SERVICE INSTRUCTIONS

FIELD REPLACEMENT KIT TRANSFORMER 062880

WIRING DIAGRAM

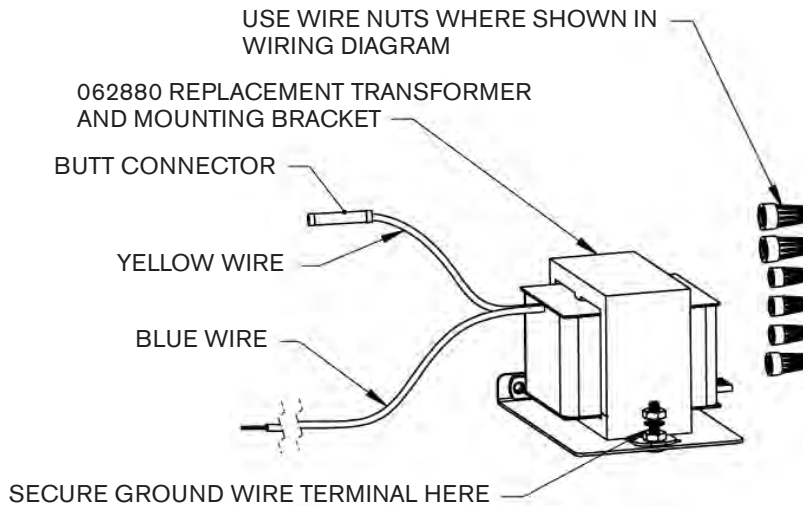
3. Note the wire colors and their connections from the 058359 transformer.
4. Locate the YEL (yellow) wire from the 058359 transformer that is solder-connected to the Bridge Rectifier lead. Measure about 2" from the rectifier and cut this lead.

5. Disconnect the remaining wires from the 058359 transformer. Remove the transformer and its bracket from the power supply assembly.
6. Install the new 062880 transformer and bracket into the power supply assembly.

7. Insert the stripped end of the yellow wire from the Bridge Rectifier into the open end of the butt connector on the YEL (yellow) wire of the new transformer. Crimp to make a permanent connection. Perform a pull test to insure that the wire has been properly crimped.

8. Using the supplied wire nuts, re-connect the remaining transformer wires as they were originally connected to the unit (use the correct wire colors as shown on the wiring diagram). Make certain to cap off the unused wires with the gray wire nuts (supplied).
